ITEM FOR ENVIRONMENTAL COMMISSION AGENDA

COMMISSION MEETING DATE:	July 7, 2021
NAME & NUMBER OF PROJECT:	SP-2021-0015D; Cross Roads Logistics
NAME OF APPLICANT OR ORGANIZATION:	Michele Rogerson Lynch & Steve Jamison
LOCATION:	8400 E. Parmer Lane, Austin, Texas, 78653
COUNCIL DISTRICT:	Not applicable – ETJ
ENVIRONMENTAL REVIEW STAFF:	Hank Marley, Environmental Review Specialist Senior, Development Services Department, 512-974-2067, hank.marley@austintexas.gov
WATERSHED:	Gilleland Creek Watershed, Suburban, Desired Development Zone
REQUEST:	<p>Variance request is as follows:</p> <ul style="list-style-type: none">• Request to vary from LDC 25-8-341 to allow cut up to 14.3 feet within the Desired Development Zone.• Request to vary from LDC 25-8-342 to allow fill up to 16.5 feet within the Desired Development Zone.
STAFF RECOMMENDATION:	<p>Staff recommends this variance, having determined the findings of fact to have been met.</p>
STAFF CONDITION:	<ul style="list-style-type: none">• Provide a landscape plan in accordance with City zoning jurisdictional requirements.• Provide tree replacement/mitigation plan in accordance with City zoning jurisdictional requirements.• Increase the wetla

CROSSROADS LOGISTICS CENTER
CUT & FILL EXHIBIT
8400 E. PARMER LANE
AUSTIN, TEXAS 78653

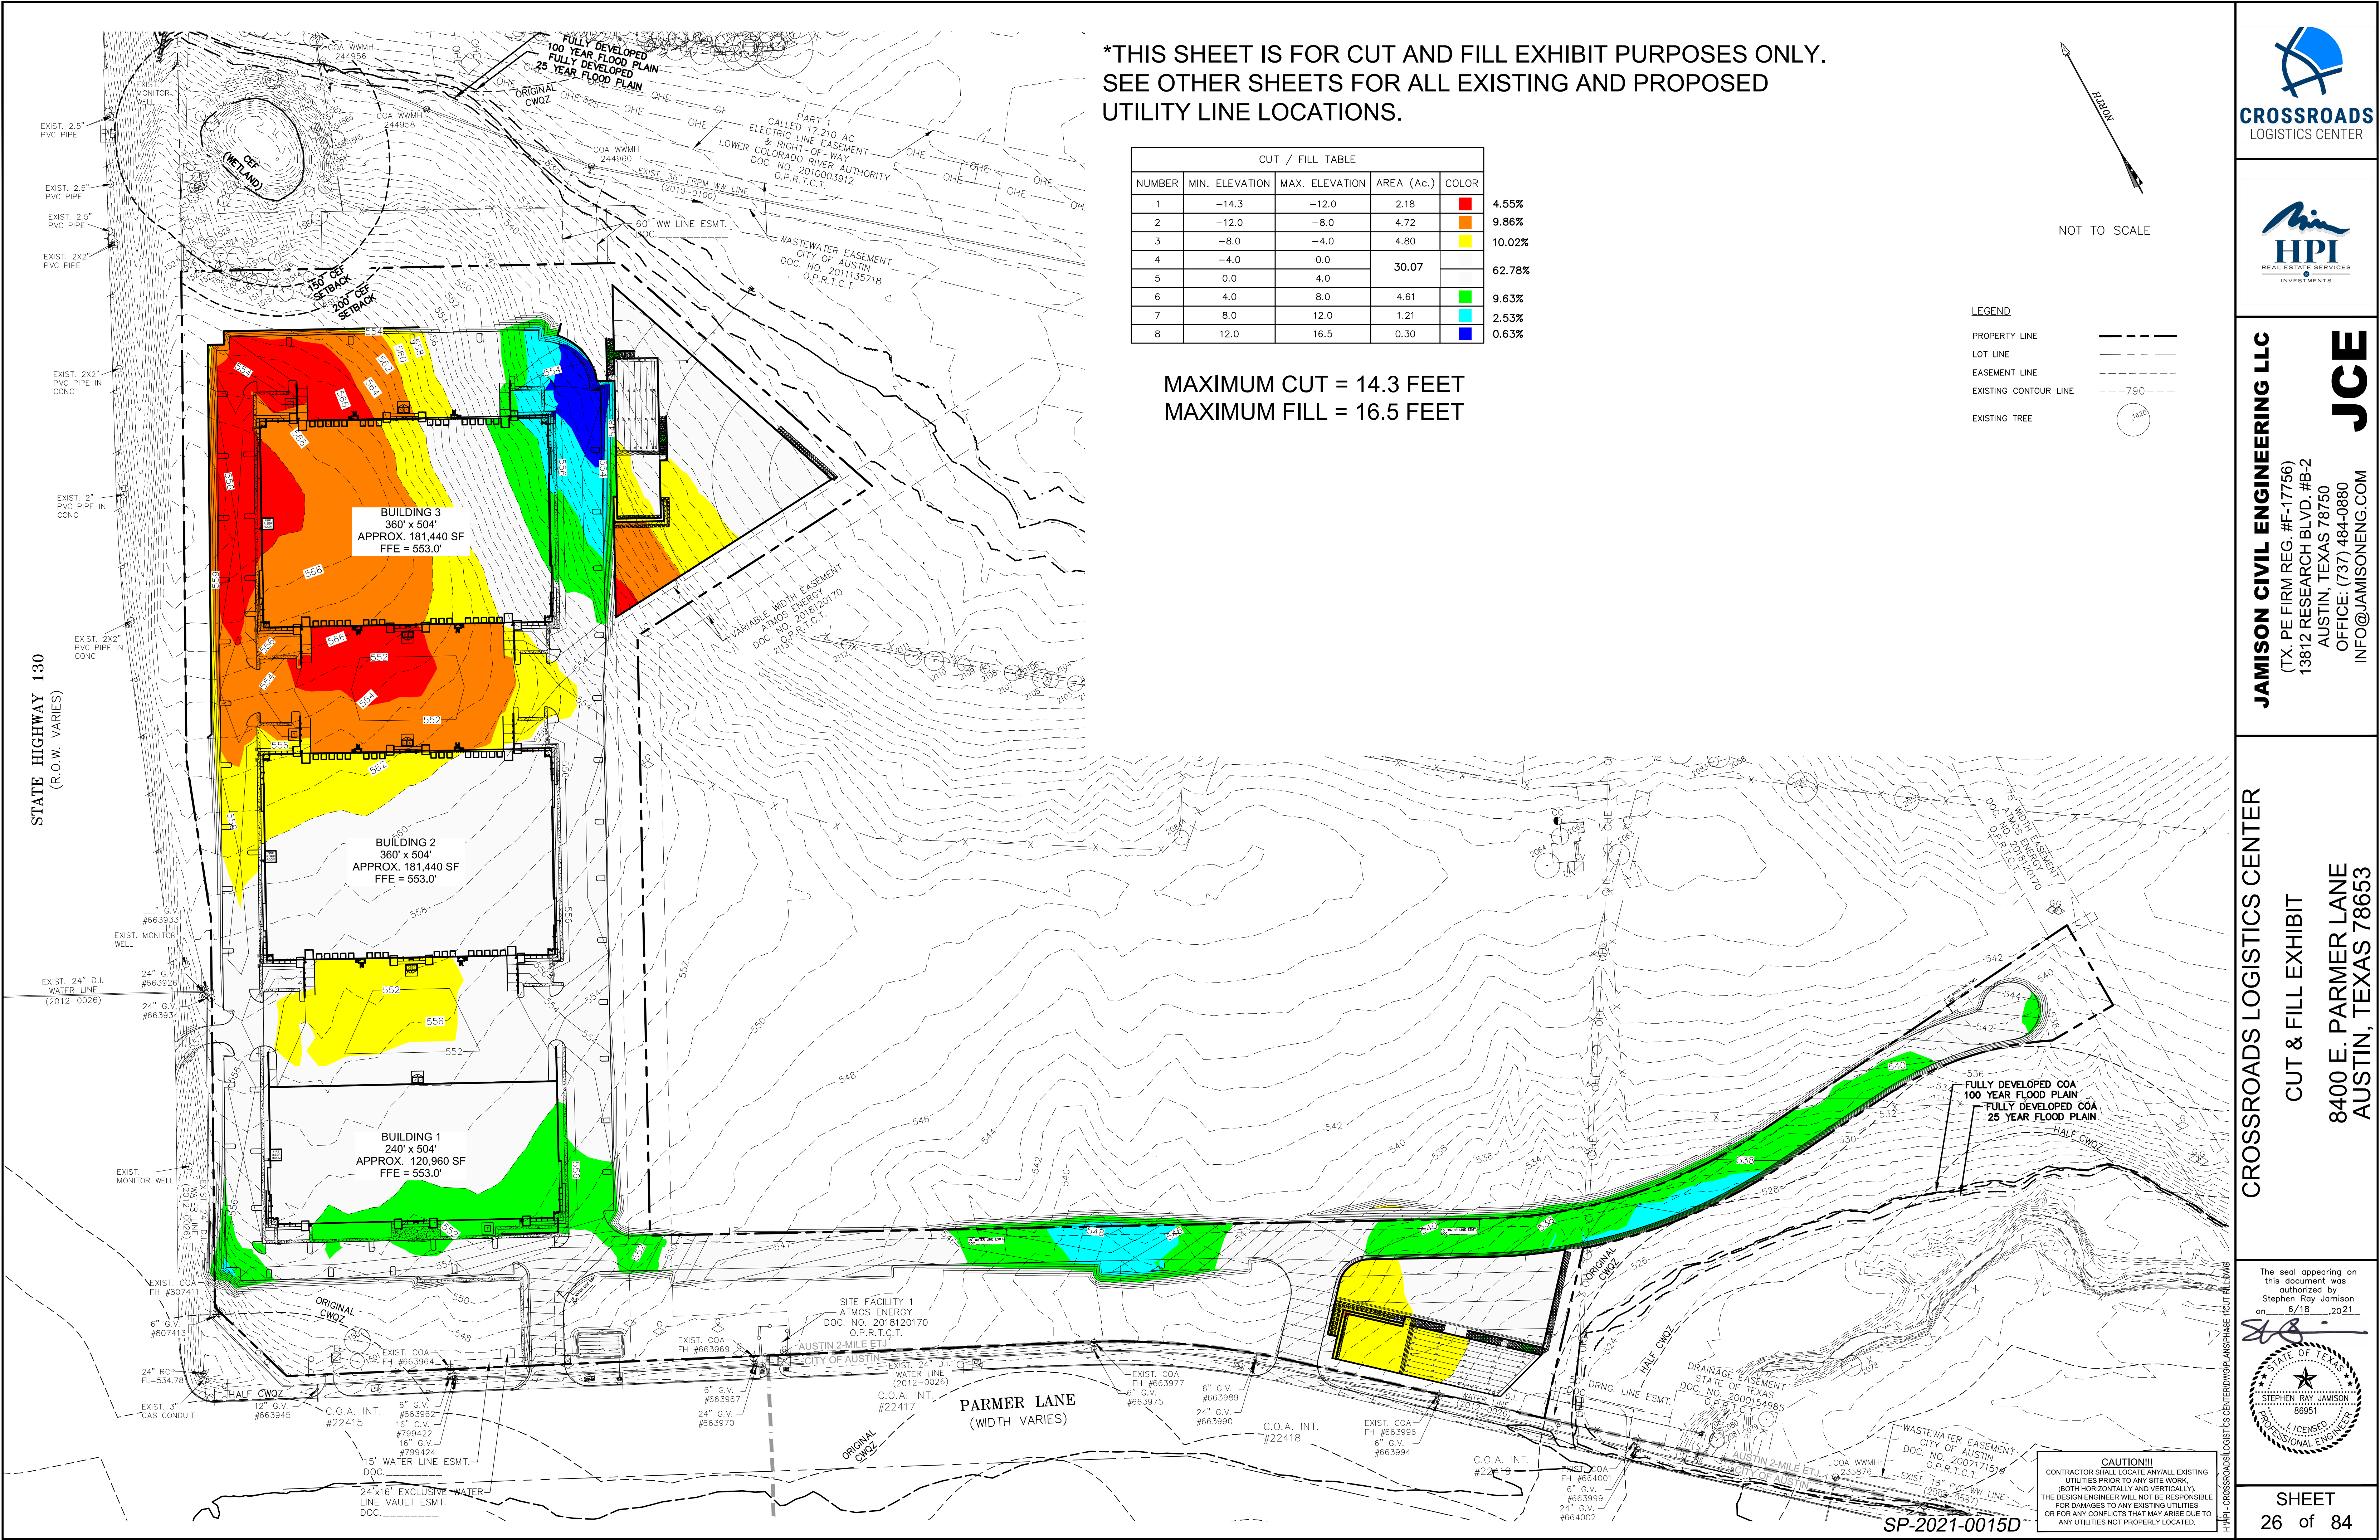
Staff Determination: Staff determines that the findings of fact have been met. Staff recommends the following condition:

Variance Request: To allow fill up to 16.5 feet within the Desired Development Zone.

- Provide a landscape plan in accordance with City zoning jurisdictional requirements.
- Provide tree replacement/mitigation plan in accordance with City zoning jurisdictional requirements.
- Increase the wetland CEF setback from 150 feet to 200 feet.
- Provide structural containment of the cut with retaining walls.

- Provide a landscape plan in accordance with City zoning jurisdictional requirements.
- Provide tree replacement/mitigation plan in accordance with City zoning jurisdictional requirements.
- Increase the wetland CEF setback from 150 feet to 200 feet.
- Provide structural containment of the fill with retaining walls.
